To the Durham Planning Board

Comments/suggestions on landscape plan for Mill Plaza development plan

From John Parry, 5 Denbow Rd., Durham, NH

Urban Forester, U.S. Forest Service (retired)

**1 PROTECTION FOR EXISTING TREES**  
 Scale: Not To Scale

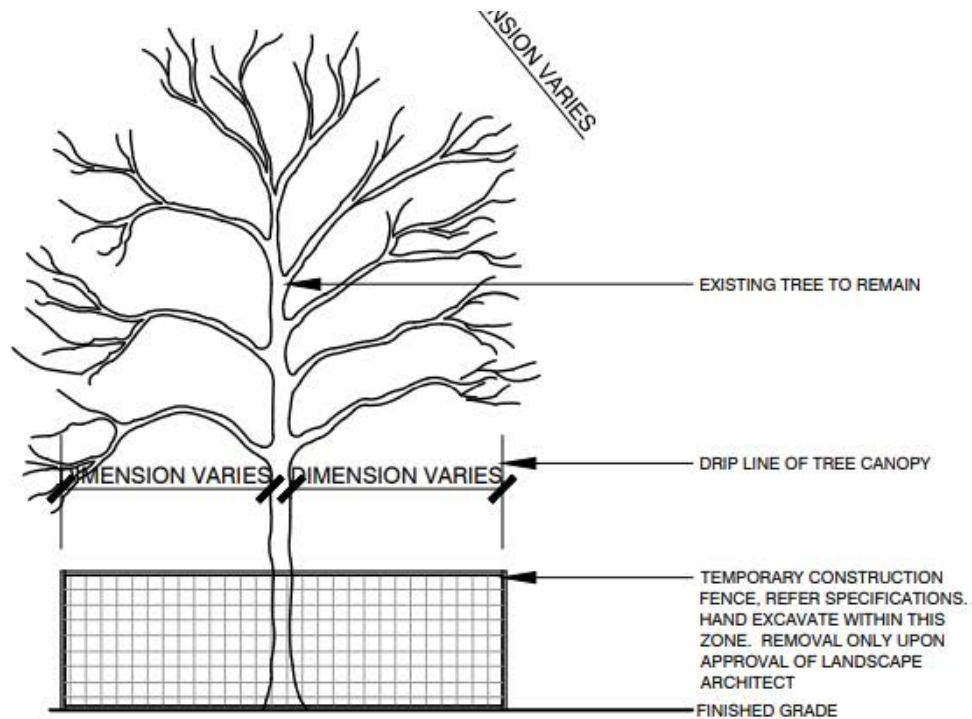
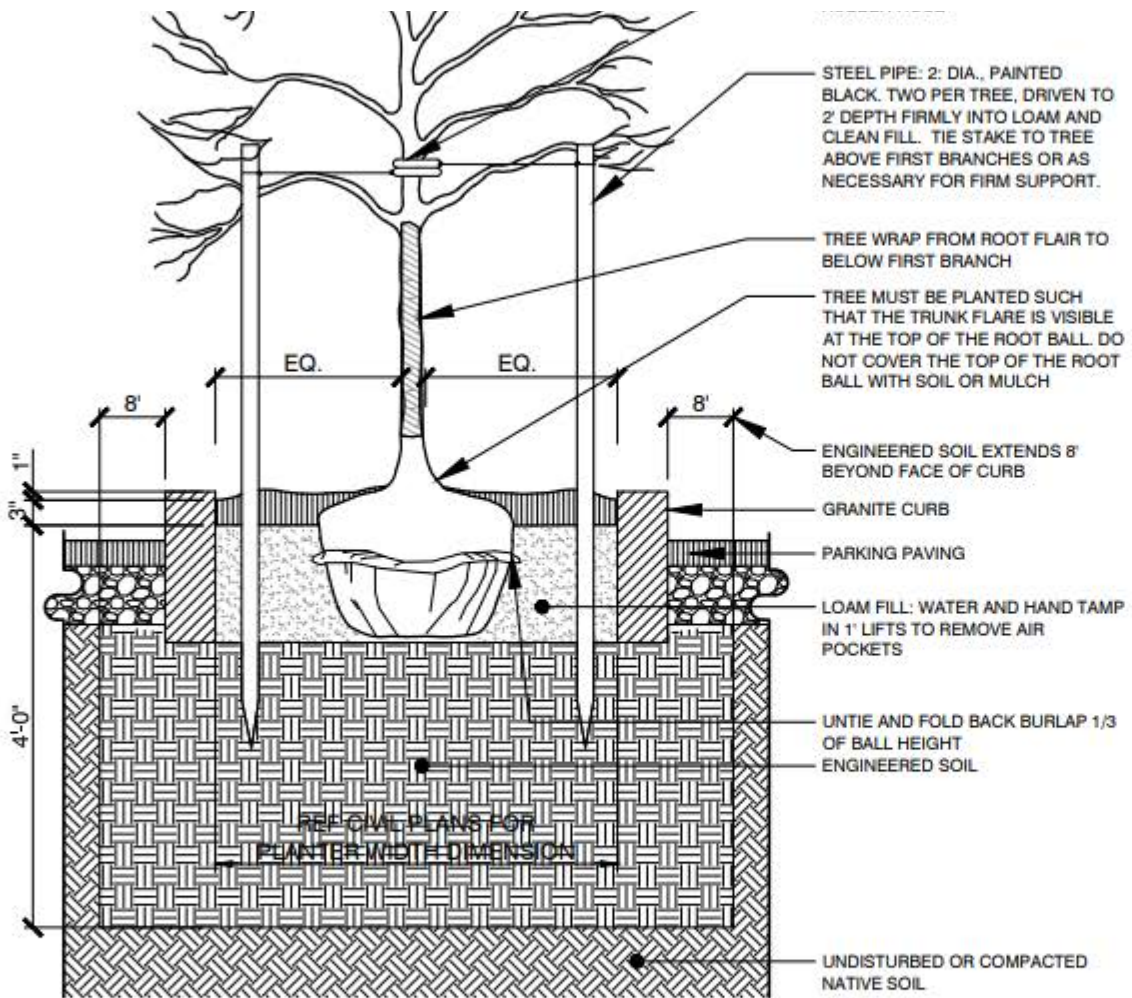
- Protecting root zone around the tree is critical. Fencing at the drip line is an accepted industry standard\*. The wording in 17. above “or at an **8 foot minimum**” is **contradictory and not adequate** for larger trees over 8” in diameter.
- There are **two different diagrams in the plans** showing different levels of tree protection (see below). The first figure below (from Sheet C508) shows fencing at 6 feet. The **protection standards for existing trees are confusing and need to be clarified.**

**4 DECIDUOUS TREE PLANTING: CENTER PARKING ISLAND**

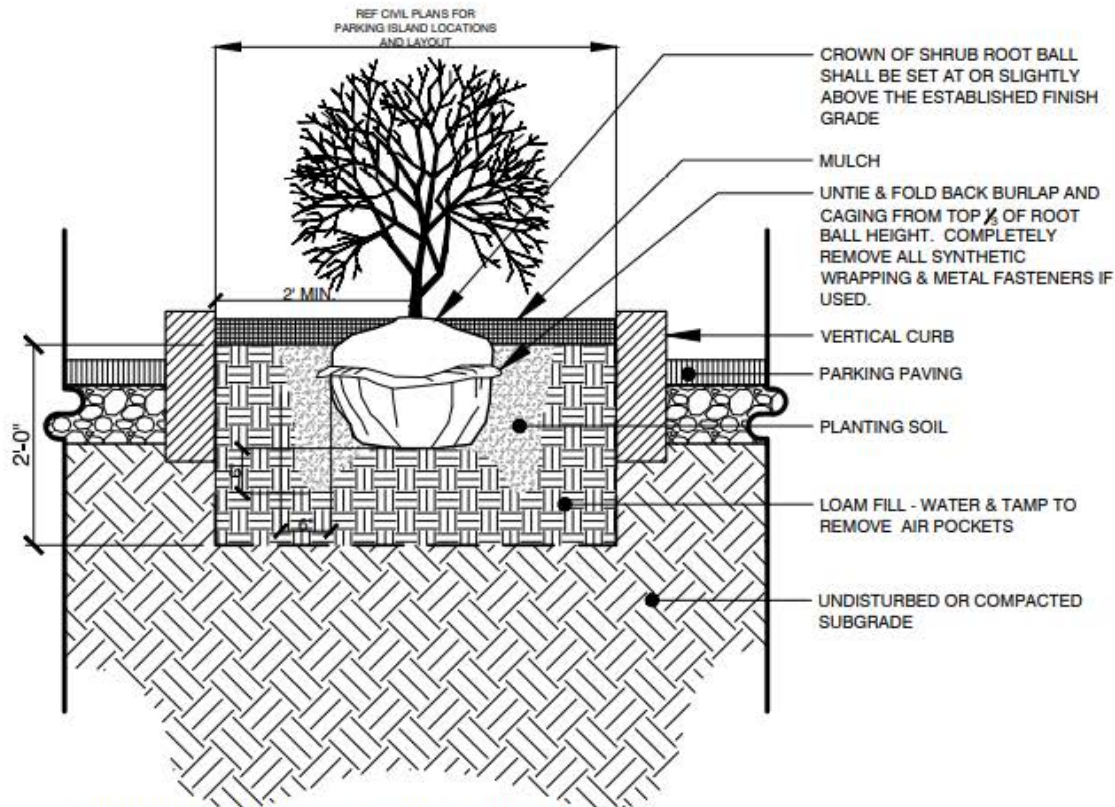
- The islands are 6 feet wide. My understanding is that measurement is to the outside of the curb, so the curbs will take up about 12+ inches of the island space. That **leaves just 5 feet or less of soil width for tree rooting** in the islands. Some of the species selected can grow to a large size at maturity when adequate space is available. Trees in the existing lot, and on main street are examples of what happens long term without adequate rooting space. Most roots naturally grow horizontally from the root ball. I am glad to see species were selected that will have a larger size at maturity, but I feel **the width of the Islands should have been increased (to at least 8 feet) to allow adequate**

- I see the engineered soil will be used and extends 8 feet past the curb, underneath the pavement. Glad to see you are considering engineered soil. This will help, but may not totally make up for the limited rooting space of soil at the level of the root balls. The engineered soil is placed underneath the tree root balls to a depth of 4 feet. Most tree roots grow laterally from the root ball in the top 2 - 3 feet of soil\*.

- Plan states that "Engineered soil extends 8' beyond curb". This **engineered soil should be defined or described** somewhere.
- It will be helpful that the roots can run down the length of the islands, however this will be a diminishing return. There will be less root growth farther from the tree, and there will be competition for water and nutrients from shrubs and other plant material in those areas. Also, it appears the **engineered soil does not run the full length of the islands, so in between the trees the rooting depth is more limited and soil may be more compacted.**

- There is **no engineered soil shown under the planned shrubs in the island, so that implies that the engineered soil does not run the full length of the island and is only near the trees? It would be useful to know how far the engineered soil extends around the trees.**

- The tree planting figure above shows the root ball planted high, about  $\frac{1}{4}$  of the root ball is above the soil. **I feel this is inappropriate. Trees should be planted so that the root flare is at or near ground level\***. If soil settling is a concern trees can be planted slightly high (no more than 1 – 2 inches). The **ANSI standard for planting** (ISA Tree Planting BMPs – Companion Publication to ANSI A 300 Part 6) states that “B&B root balls should have the trunk flare correctly located at the surface – the planting hole can be 1 -2 inches shallower than the root ball depth in anticipation of minor settling and flattening of the root ball”.
